Technical Service Bulletin

Date: 1/3/2025	Editor: Rfiester/Mchampeau	Form ID: TSB25001
--------------------------	--------------------------------------	-----------------------------

Component	DEF Sensor
Apparatus Make & Model	Rosenbauer Commander, Avengers, and Warrior
Affected apparatus	All RBA Chassis 2017 and newer

Complaint	DEF Sensors fails
Cause	Coolant Control Valve Plumbed Backwards
Priority Level	high

Figure 1

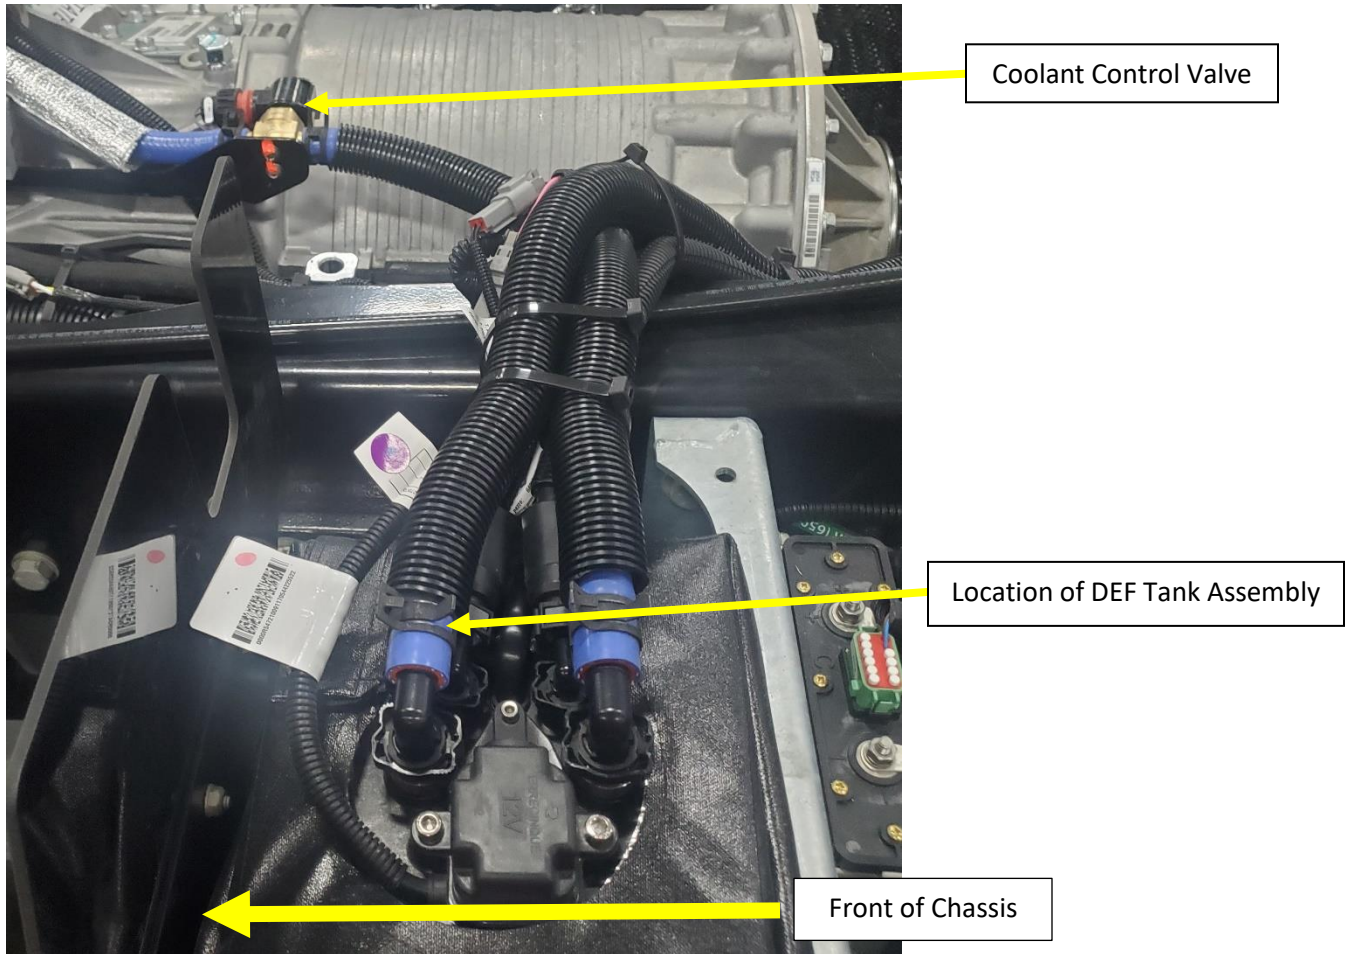
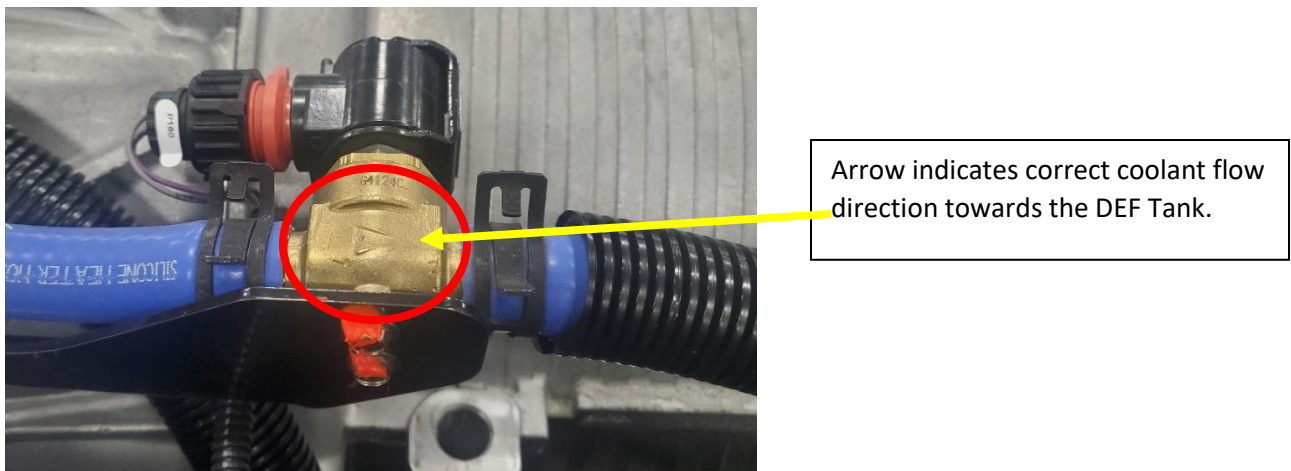
1. Locate the coolant control valve. Located under the cab, on the driver side of the transmission (*Figure 1*).

- a. Please note the location of the DEF Tank assembly.
2. On the coolant control valve, ensure that the arrow is pointing in the direction of the DEF tank.

3. If the coolant control valve is pointed in the direction of the DEF tank, no further action needed.

If the coolant control valve is discovered to be plumbed backwards, please open a SRS ticket to report the issue and get the needed parts.
